Docket Item #4 A-F
EESAP Blocks 11 & 12 - 2210 Eisenhower Avenue

Application	General Data	
Project Name: Eisenhower East Blocks 11 & 12	PC Hearing:	April 6, 2010
	CC Hearing:	April 17, 2010
	If approved, DSUP expiration:	April 17, 2013 (36 months)
	Site Area:	Block 11: 126,010 sf (2.89 ac) Block 12: 59,653 sf (1.37 ac)
Location: 2210 Eisenhower Avenue	Zone:	CDD#2
	Proposed Use:	Residential & Retail
	Gross Floor Area:	Block 11: 674,259 sf Block 12: 641,964 sf Total: 1,317,304 sf
Applicant: Hoffman Company, LLC by Kenneth Wire, McGuireWoods LLP	Small Area Plan:	Eisenhower East
	Green Building:	LEED Certified or 1 Green Globe (& min. 40% of possible Green Globes points)

Purpose of Application
 Stage 2 DSUP approval for development of two blocks in the *Eisenhower East Small Area Plan* area. The proposal includes two residential/retail mixed-use buildings on the east side of the Eisenhower Avenue Metro Station, name approvals for two new public streets – Anchor Street and Swamp Fox Road – and the new Eisenhower Station Square at the renovated Eisenhower Avenue Metro Station.

Staff Recommendation: APPROVAL WITH CONDITIONS

Illustrative C:

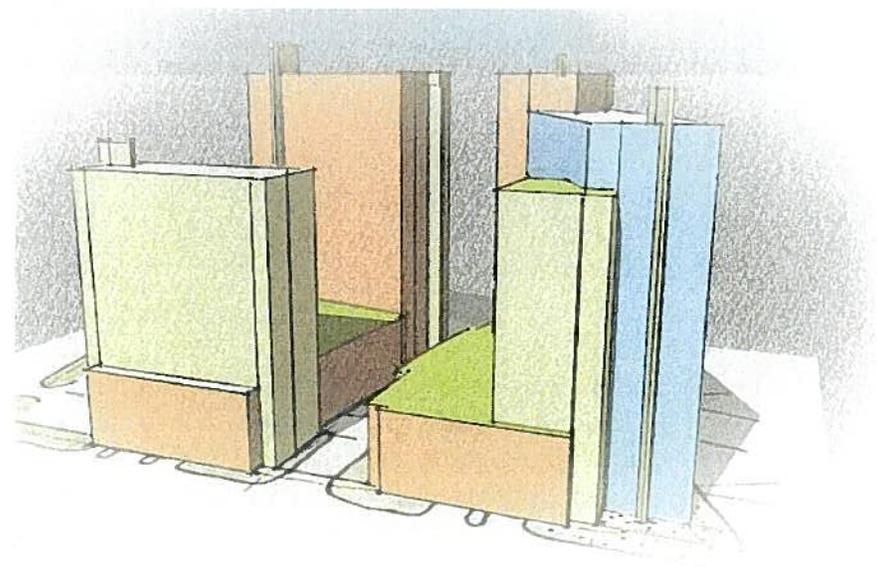
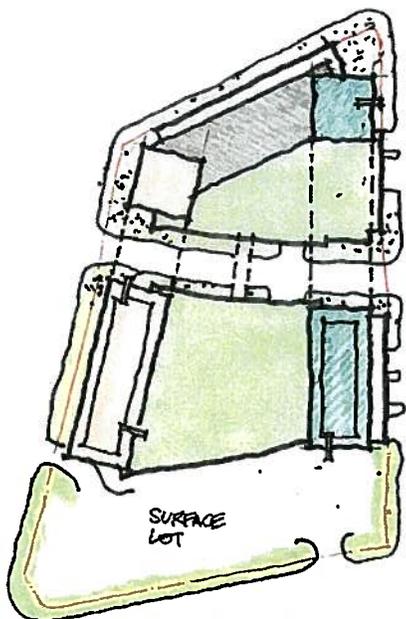
In this design, there were two levels of underground garage proposed over the entire site (with the exception of the surface parking lot, which is encumbered with a DVP underground easement that precludes below-grade construction.) Staff expressed concerns with several aspects of this design: the lack of three-dimensional articulation and building top expression; the repetitive quality of three same-height towers with the identical skin treatment, regardless of site context; the dated appearance of towers sitting on a podium; the treatment of Dock Lane, with blank parking garage walls and speed ramps running continuously along both sides; and a lack of ground-level public open space. Although Dock Lane was designated in the EESAP as a “C” street, design evolution that occurred during the approval of the neighboring Lane project to the east has effectively changed the character of this street into a more important pedestrian thoroughfare, connecting the Lane project and existing residential to the east with the Eisenhower Metro station, through the subject property. In keeping with this, staff has encouraged the applicant to make Dock Lane a more pedestrian-friendly street. This included suggestions to move or reduce the number of garage ramps, lower podium heights to increase solar access to the street, and above all create more active uses on Dock Lane. Staff repeatedly asked to add a second entrance to the proposed Harris Teeter on Dock Lane, which the tenant opposed. Staff felt strongly that the primary retail tenant in this development should not “turn its back” to Dock Lane and Eisenhower Avenue. Subsequent revision of garage ramps to their current configuration would allow such a connection, but the space opened up is currently shown as a secondary retail space on Block 11 with the secondary entrance to the grocery store located on the façade facing the Metro station. To further activate Dock Lane, the applicant has proposed a series of small “pocket retail” spaces – basically micro shops – that would support small retail uses, and add life and activity to the street frontage. For further discussion of the Dock Lane issues, see also the Block 12 Parking discussion (below.)

Subsequently, staff met with the applicant on an ongoing basis to work through these concerns. Applicant stated that the project's economics made strong three-dimensional stepping or plan setbacks problematic, and proposed achieving height variation by seeking additional height

Current Design:

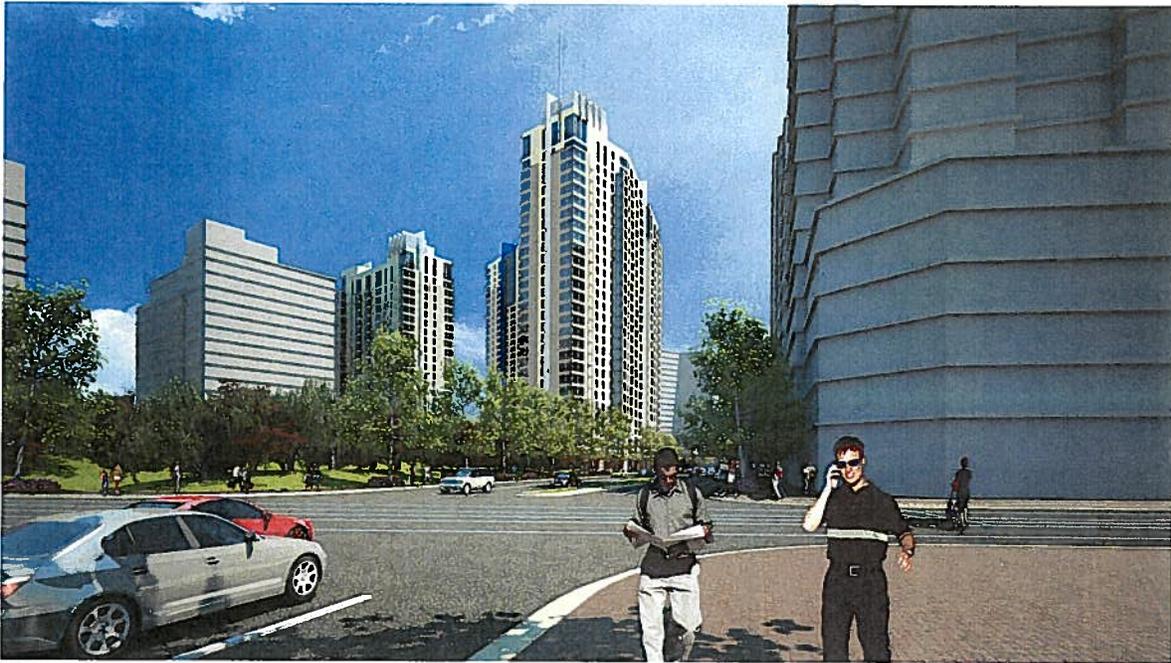
Staff analysis of the current design, based on submissions dated February 16th and March 16th and March 23rd, 2010, recognizes that Applicant has made substantial progress with the building design, but notes a few remaining areas of concern, which staff believes could be resolved at Final Site Plan with the applicant and their design team. Staff therefore recommends approval of this Stage 2 DSUP application, with the conditions listed in the Building Section of the Recommendations.

Illustrative F: Staff Alternate Ground Floor Plan - Expanded Retail Space shown in blue
 Note that retail elevator location gives direct access to Eisenhower Avenue and lease space.

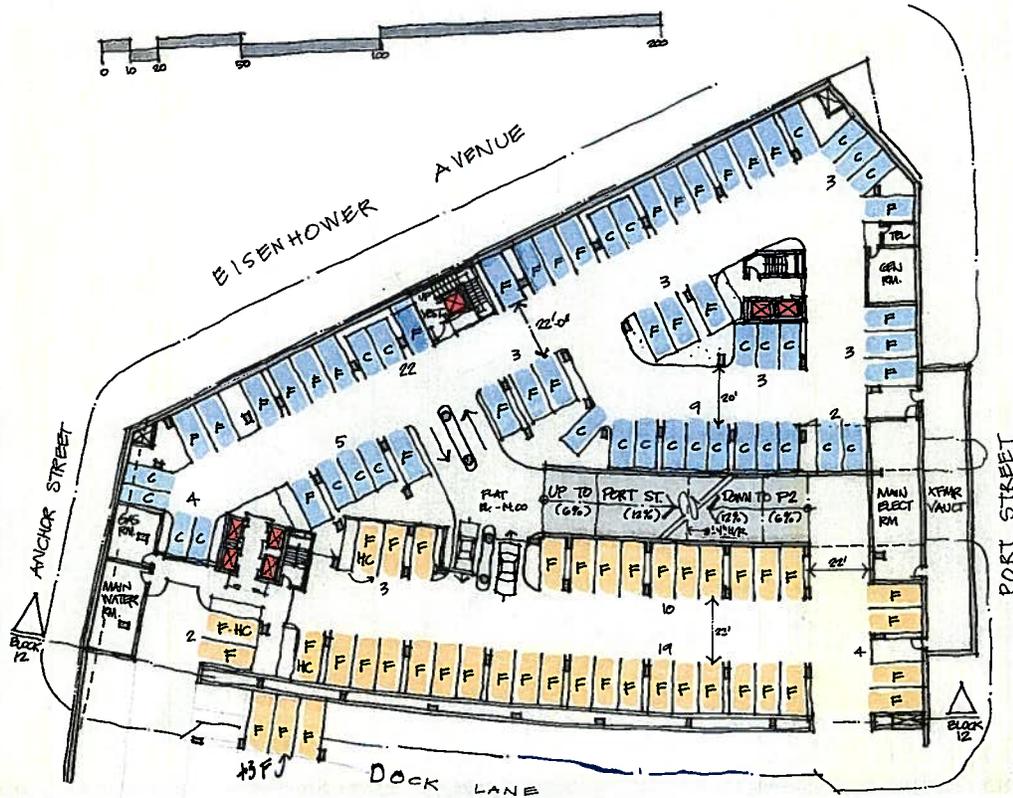
opportunities for future restaurants in Block 12, and is also large enough to accommodate retail kiosks, such as the ones found in Bryant Park and elsewhere in Manhattan. The plan changes also allow for greater retail depth (an industry-standard 70-80 feet, versus the 50 feet shown in the current proposal,) and the elevator location – close to Eisenhower Avenue - allows for complete flexibility in retail tenant sizes (versus the current proposal, which requires a passageway at some point, cutting the retail space in half.) This consolidated retail space gains substantial exposure as well, since it would also be visible *and* accessible from the newly-created open space, and its single parking entrance on Port Street is immediately visible to anyone coming to the retail, whether from Southern Street, Dock Lane or Eisenhower Avenue eastbound or westbound. Replacing the two ramps on Dock Lane with a single entry on Port Street also adds a significant number of on-street parallel parking spaces on Dock Lane (from 11 to 17.) Elimination of the above-grade parking structure also allows increased efficiency by relocating tenant and leasing office spaces currently shown on a single-loaded corridor on the second floor facing Port Street to the main building corridor, along with a net gain of 3 – 4 additional dwelling units, and elimination of an exit stair necessitated by the long dead-end corridor in the current proposal. Finally, removal of three levels of mechanically-ventilated garage would save total construction costs in the neighborhood of \$4 million. While these changes would involve some minor adjustments to column and core locations in Block 12, it should be noted that this piece of the project has been identified by the Applicant as Phase II, and there is therefore ample time to make these design changes without impacting the construction schedule for the overall project.

A Bryant Park Kiosk (about 20' square)
 Could supplement retail activity in open space.

Illustrative G: Staff Alternate First Garage Plan (P-1 Level) - Retail Parking is shown in blue, and could easily be expanded by moving the division between retail and residential garage sections.

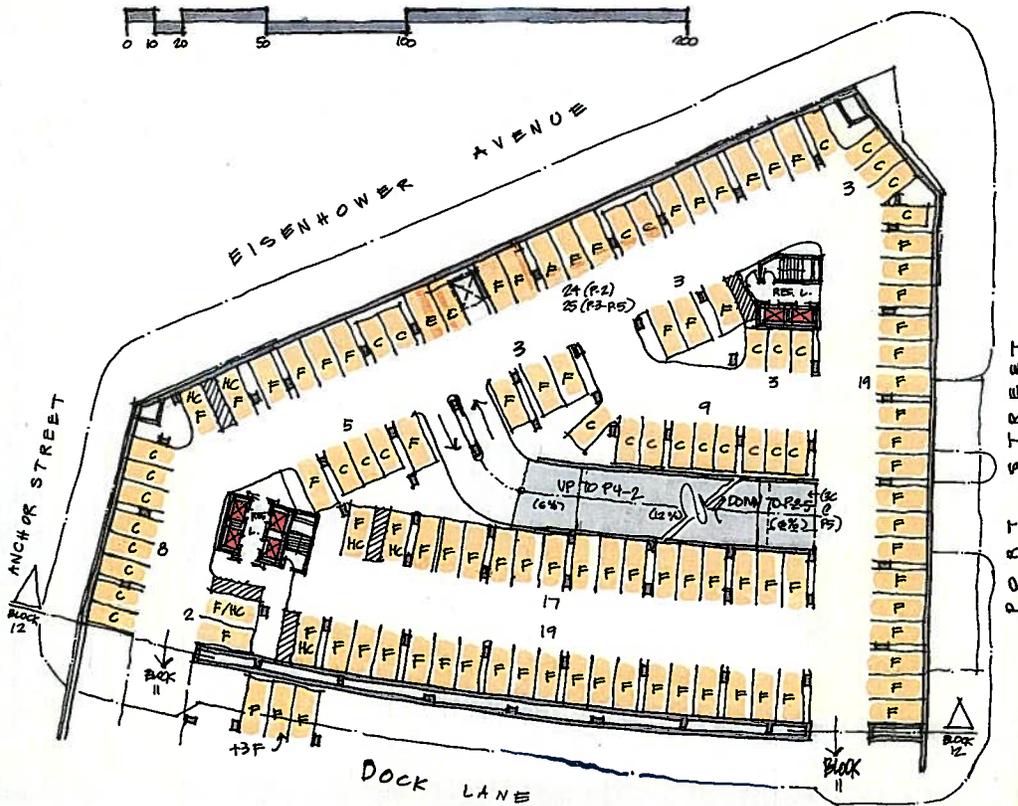
A study of the proposed garage for Block 12 (designated by the Applicant as Phase II) shows that reconfiguration of the garage could yield much greater efficiency, higher parking yield, ground level open space, and a more efficient floor plan with additional residential units on level 2, with a total net gain (on Block 12 only) of 19 parking spaces:

*) Applicant proposes a total of 95 cars on three above-grade levels - totaling approximately 65,000 square feet, which translates into \$3.5 to 5 million of construction. In

addition, this parking is very inefficient (over 750 square feet per car, versus a standard of around 350 square feet each.) The area freed up by elimination of the above-grade parking can provide over one-third of an acre of ground-level open space. The area on the 2nd floor formerly occupied by garage can then be used for additional residential units (yielding several additional units, and eliminating a redundant exit stair and long single-loaded corridor.)

Illustrative I: Staff Alternate 2nd Floor Plan – Replaces Single-Loaded Condition with Double-Loaded

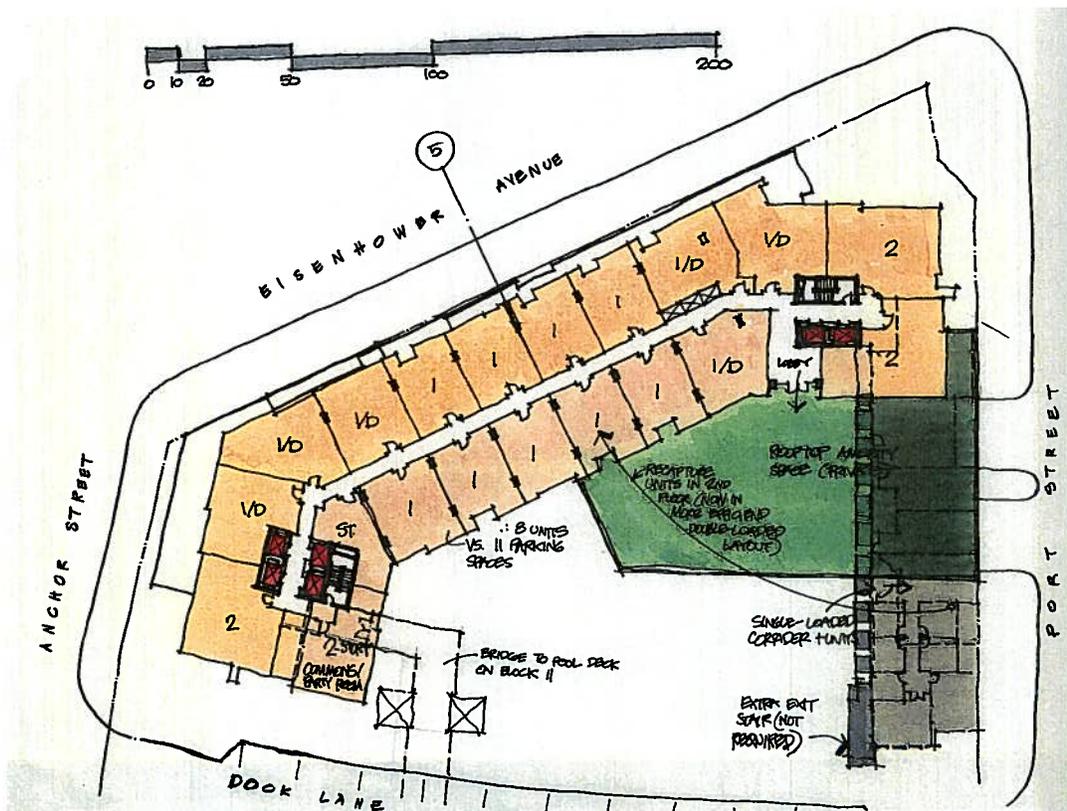
***) Applicant proposes 53 retail spaces on two separate, small levels, which makes searching for a parking space difficult; staff proposal provides 54 retail spaces on a single level, with one-stop elevator connection to retail shops and Eisenhower Avenue.

A final note: the bridge that is shown connecting Blocks 11 and 12 can still be accommodated if these changes are carried out. There is also absolutely no change suggested for Block 11, which has been designated as Phase I.

The applicant is completely unwilling to consider this change as they believe that some limited above-grade parking is essential to the success of their retail uses on Block 12. Staff is not making the provision of open space on Block 12 a condition of approval; however, believes that this is an issue that the Planning Commission and City Council should discuss with the applicant.
